**From:** [REDACTED]  
**To:** [REDACTED]  
**CC:** [REDACTED]  
**Sent:** 3/23/2021 4:13:07 PM  
**Subject:** RE: O8W-PM 35217268, 35224712, 35224713 - Bucks Creek 1101 Phase 1,2&3 - Pre-Engineering Meeting

# Bucks Creek 1101- PM# 35217268 Overview Map

PM 35217268 (Phase 1)

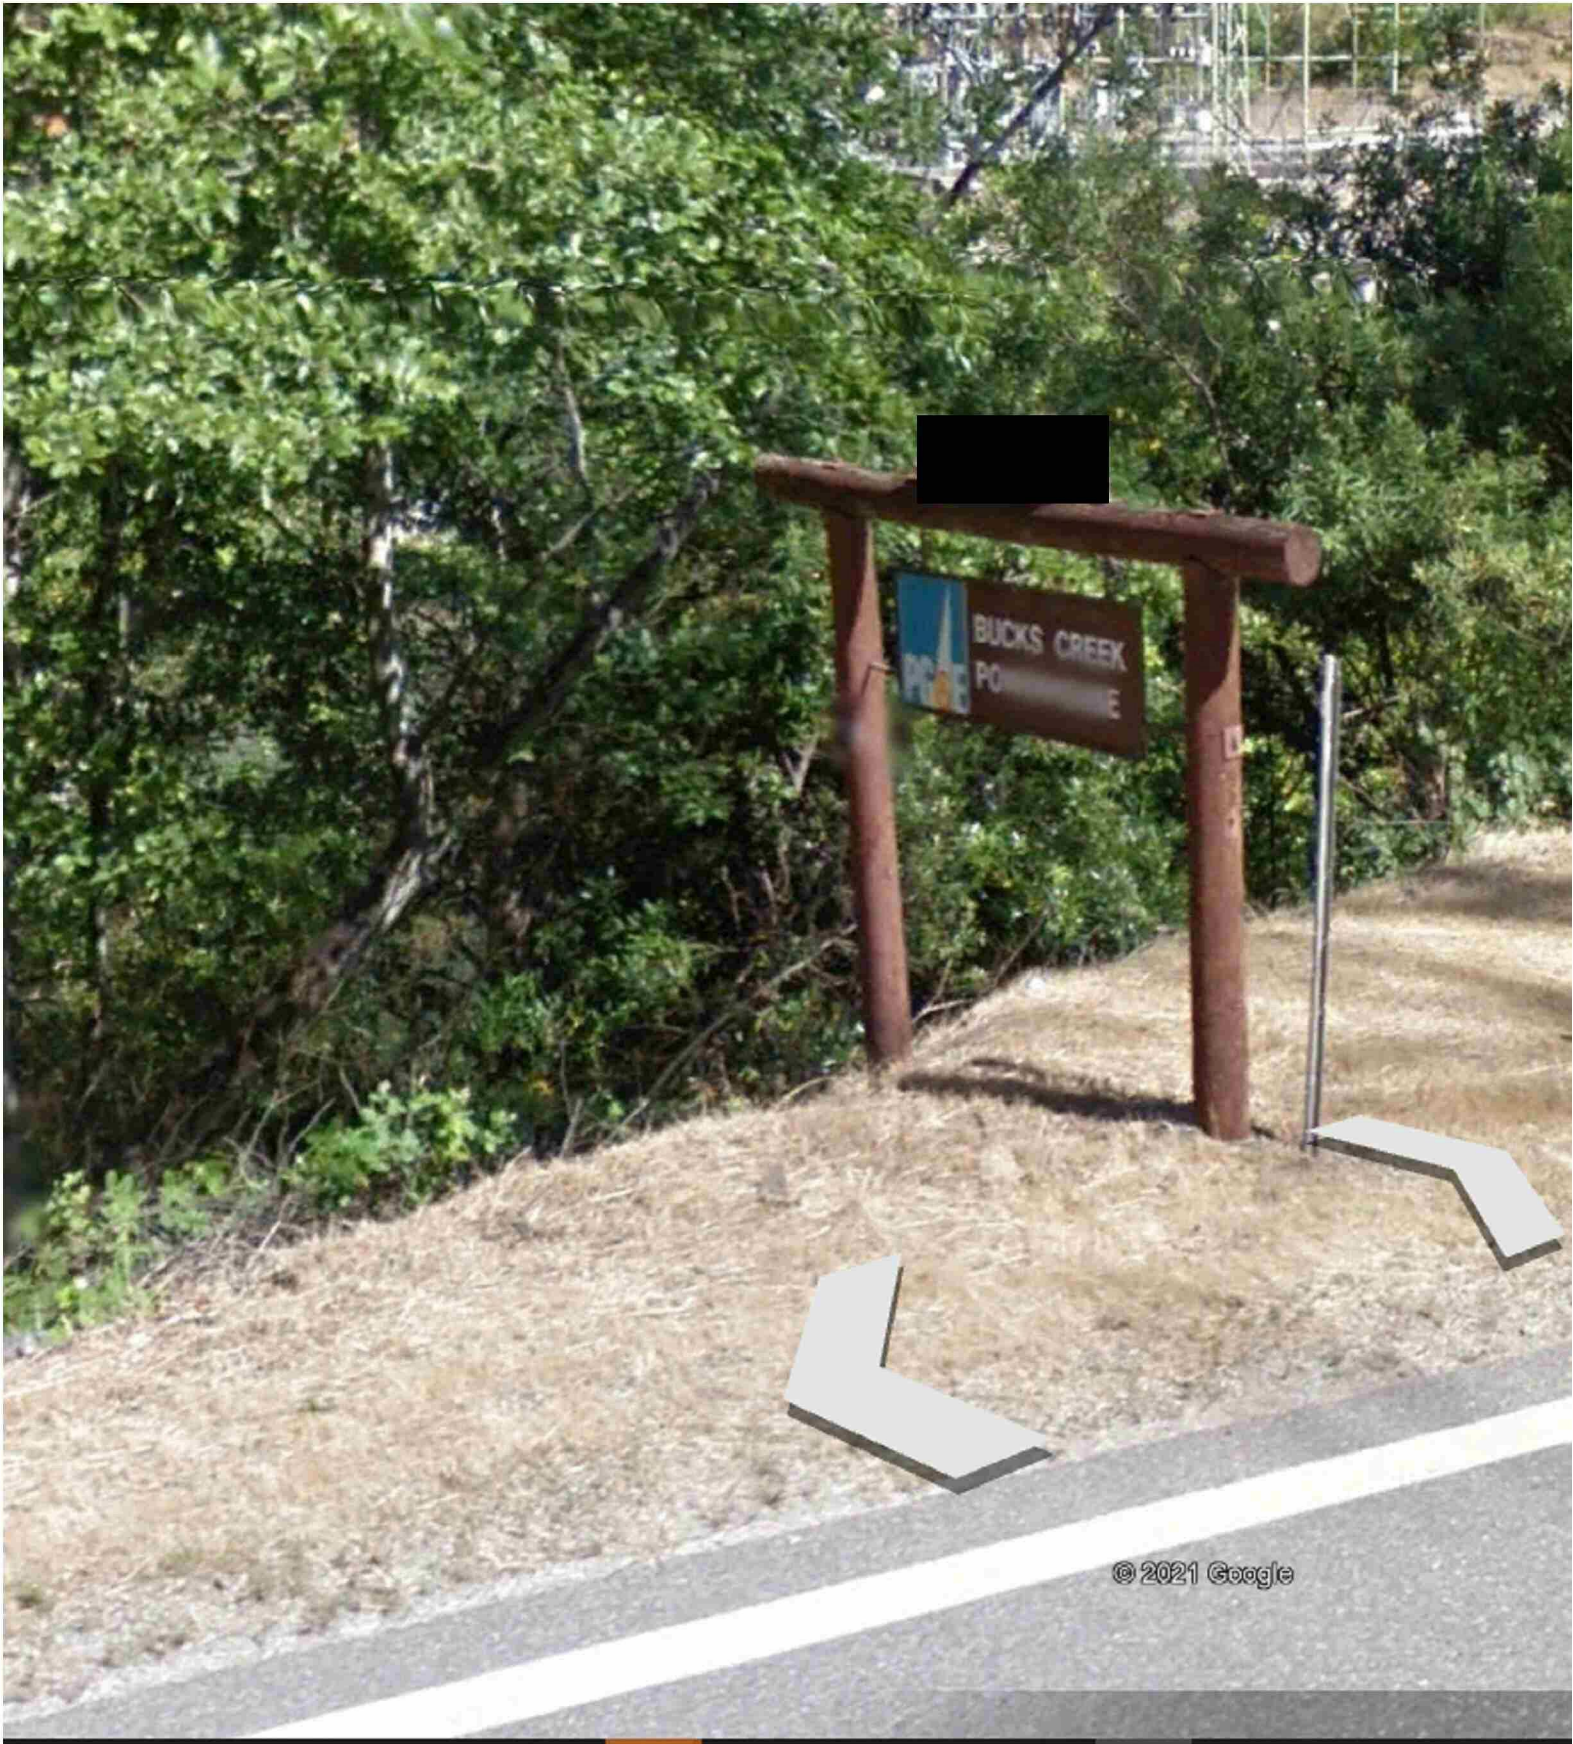
Attached are the 'base-map' limits in a kmz. file. As you will see, we need our base-map to go about ~100' into the tunnel at the south end (see pedestal in picture below....please begin about ~50 beyond this point which is about ~100' beyond the Cresta Dam).

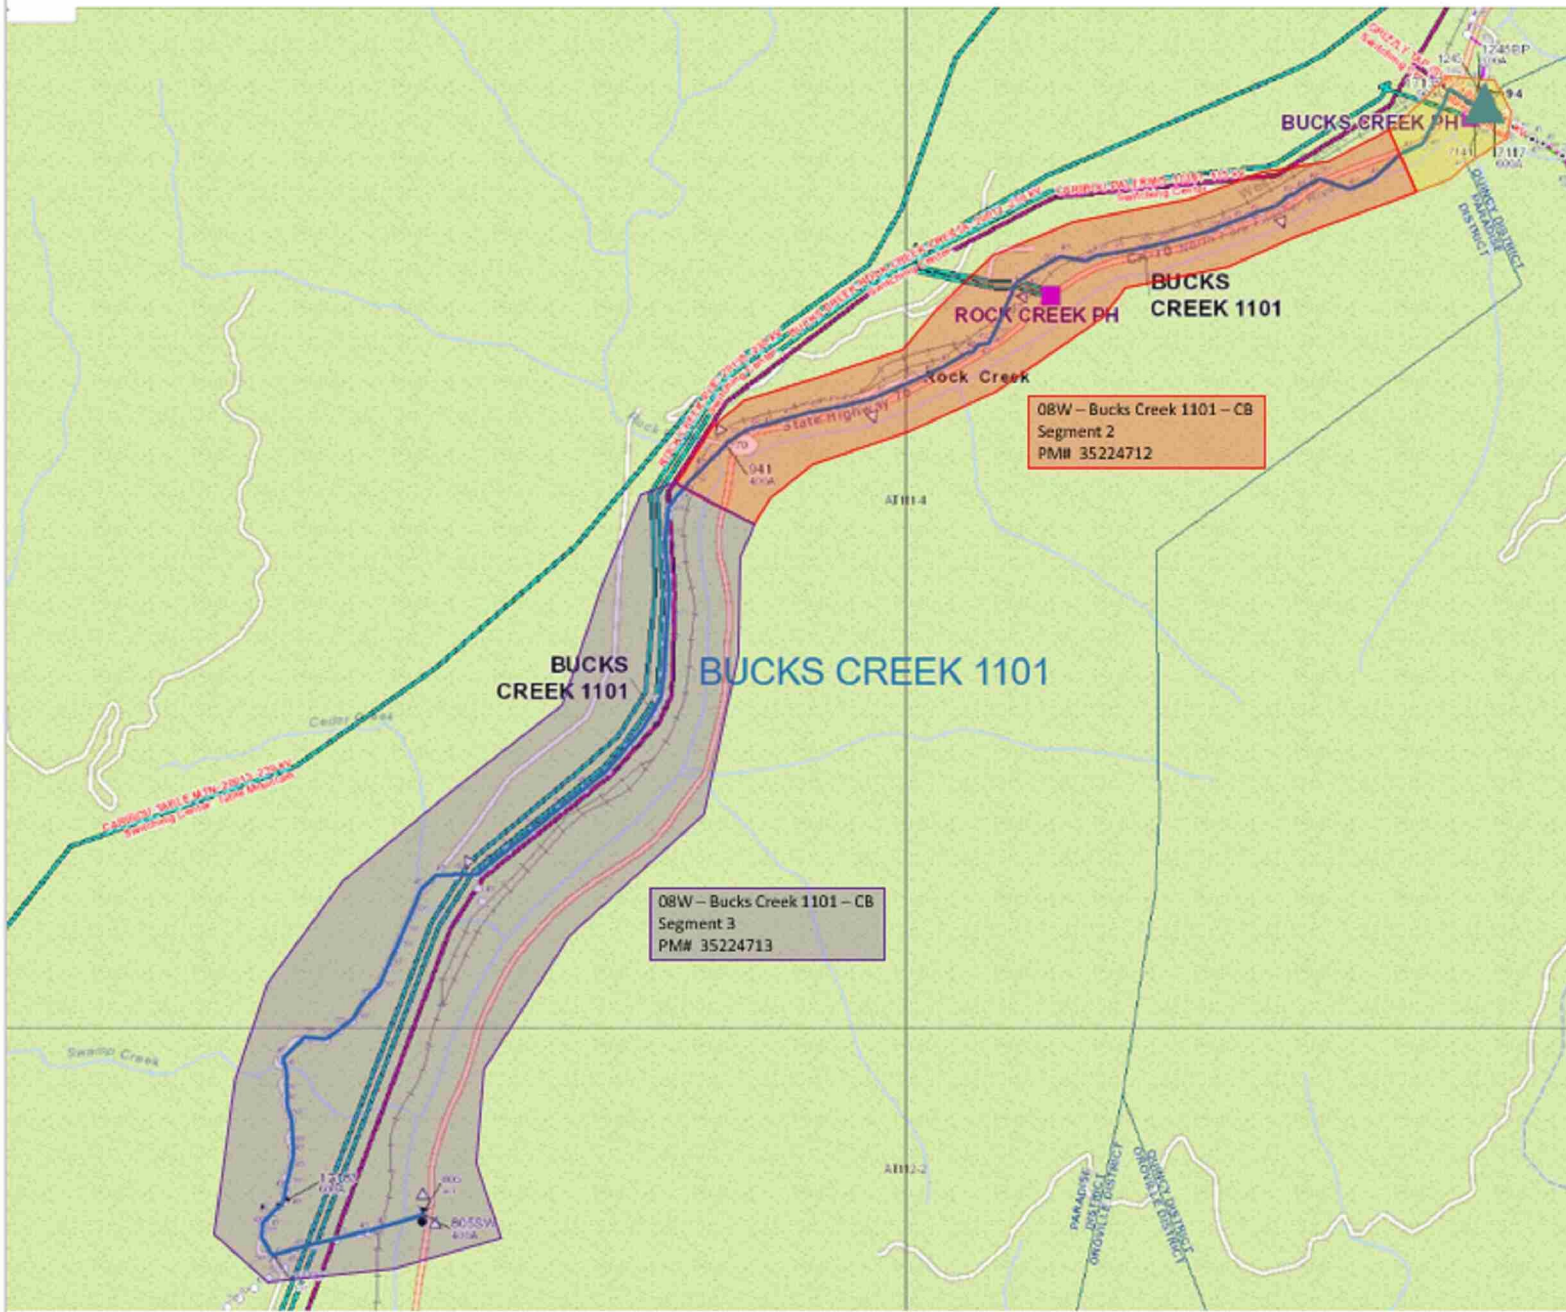
For Bucks Creek there is quite a bit of work surrounding Hwy 70 and we will need a Land Department Base Maps prepared for all 3 Orders. This will delay the EOD dates until these can be developed and provided to the Vendor... We will also need answers to the questions outlined by [REDACTED] below...
